Access Compliance Report

Public Rights-of-Way

(Curb Ramps)

Intersection ID: 31442	Main Street: LORDEN_AV	Cross Street: RIDING_HILL_AV	Location: SW
ADA ID: E844C461AF1A	Ramp Type: PerpDiag	Initial Pass/Fail: Fail	Overall Compliance: No
Severity Score: 21.25			
Codes/Mitigation Info/Possible Solution		Field Measurements/Component Compliance

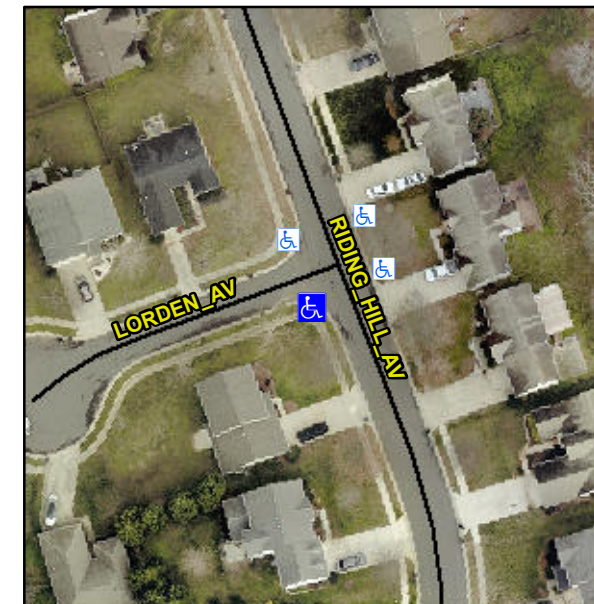
Not Found, R304.5.1, R304.5.3

Compliance	Description	Data	Compliance	Description	Data
N/A	Ramp Length (in)	50.0	Yes	Ramp Slope (%)	6.3
No	Ramp Width (in)	45.5	No	Ramp XSlope (%)	6.0
N/A	Flare Type LT	N/A	N/A	Flare Type RT	N/A
N/A	Flare Slope LT (%)	N/A	N/A	Flare Slope RT (%)	N/A
N/A	Flare Traversable LT?	N/A	N/A	Flare Traversable RT?	N/A
N/A	Landing Length (in)	N/A	N/A	DWS Provided?	N/A
N/A	Landing Width (in)	N/A	N/A	DWS Contrast?	N/A
N/A	Landing Slope (%)	N/A	N/A	DWS Length (in)	N/A
N/A	Landing X Slope (%)	N/A	N/A	DWS Full Width?	N/A
N/A	Landing Curb? (Y/N)	N/A	N/A	DWS Offset (in)	N/A
N/A	Shared Landing?	N/A			
N/A	Gutter Ponding?	N/A	N/A	Gutter Slope (%)	N/A
N/A	Gutter Lip Ht (in)	N/A	N/A	Gutter X Slope (%)	N/A
N/A	Painted X Walk1?	No	N/A	Painted X Walk2?	No
	X Walk 1 Direction	To E		X Walk 2 Direction	To N
N/A	X Walk 1 Width (in)	N/A	N/A	X Walk 2 Width (in)	N/A
	X Walk 1 Slope (%)	1.0		X Walk 2 Slope (%)	4.1
	X Walk 1 X Slope (%)	6.6		X Walk 2 X Slope (%)	2.0

Remove & Replace Curb Ramp With Two New Directional Ramps or Equivalent.
